SERVICE BULLETIN

Service Bulletin No.: DA20-79-05 Rev 3

Title: DA20 A1 - Oil Line Retrofit - F3 Engine

Figure 1

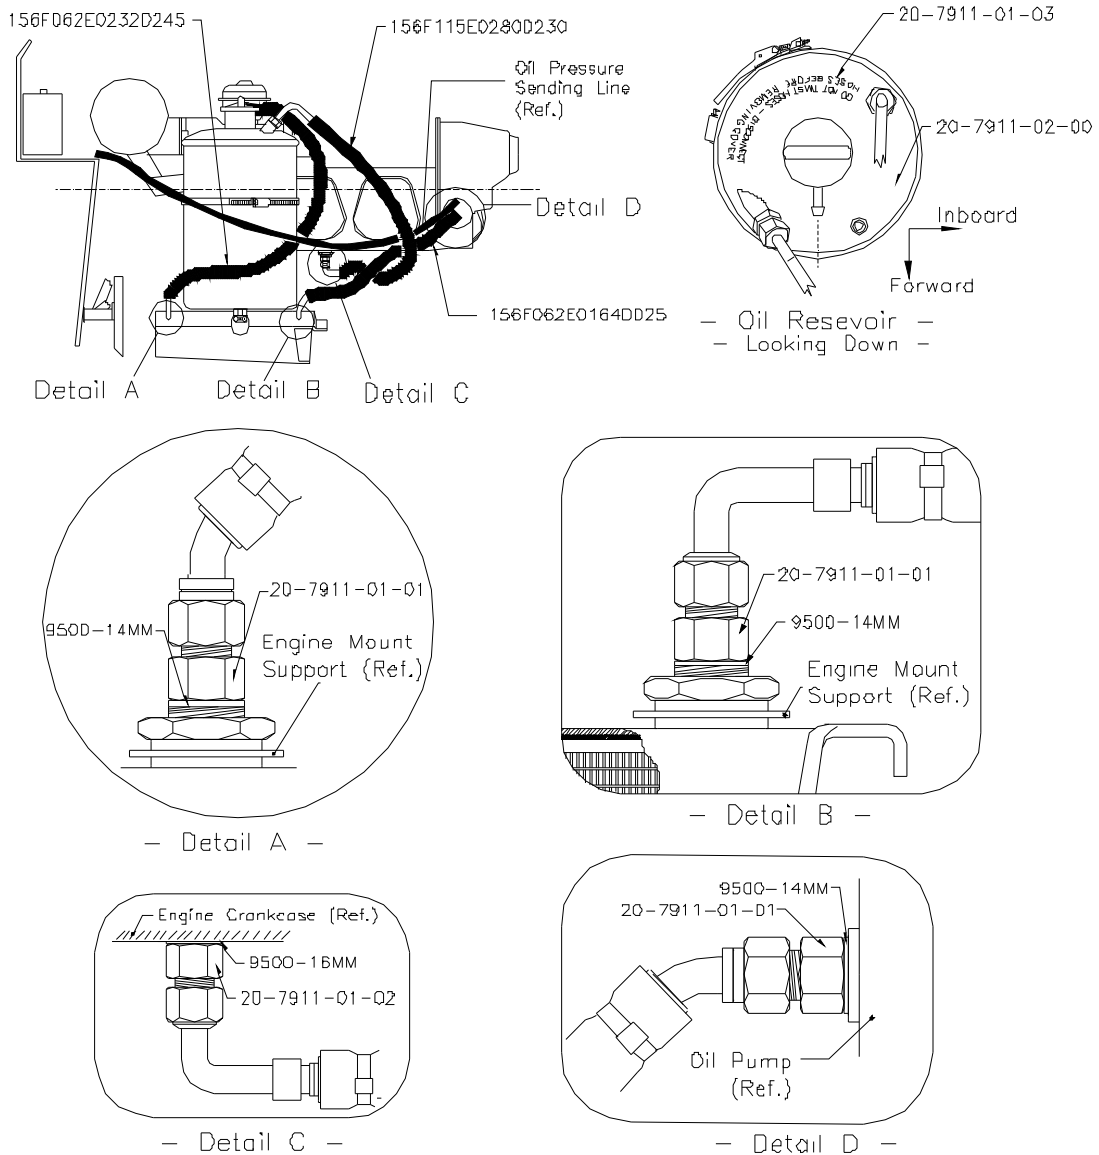
- 10.1 Remove upper and lower cowlings.
- 10.2 Remove and disassemble oil reservoir from aircraft in accordance with Rotax Maintenance Manual.
- 10.3 Assemble reservoir with supplied cover 20-7911-02-00 and O-ring 850-490 in reversed sequence of disassembly. Leave clamp loose to allow adjustment of orientation on installation.
- 10.4 Remove existing oil lines, i.e. sump to reservoir, reservoir to cooler, and cooler to pump, using a suitable container for oil.
- 10.5 Remove and discard the adapter fittings and sealing washers from oil cooler, engine sump and pump inlet.
- 10.6 Install remaining parts from kit as shown in Figure 1.
- 10.7 Torque adapters as follows:

Figure 2 - Routing and securing oil lines (RH, looking inboard)

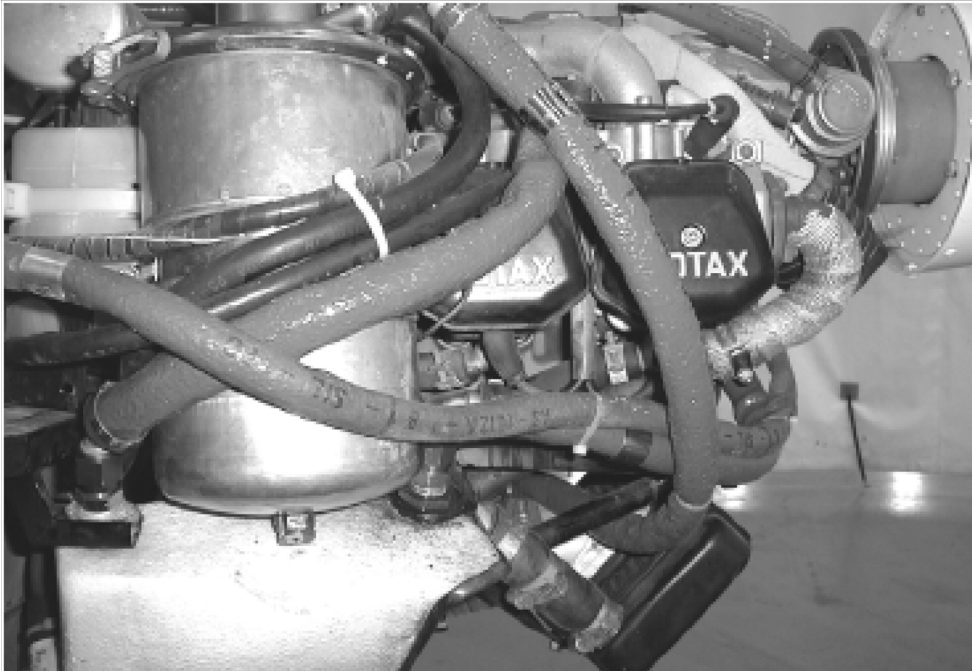
- 10.8 Route and secure oil lines as shown in Figures 2 and 3 using supplied tie-down straps, MS3367-5-9. ORIENT FITTINGS AND HOSES TO AVOID CONTACT WITH RADIATOR, ENGINE MOUNT AND CABIN HEATER SHROUD.
- 10.9 Ensure reservoir is in lowest position on engine mount. Do not allow reservoir to contact oil cooler shroud or upper surface of coolant overflow bottle.
- 10.10 Connect oil reservoir vent line.
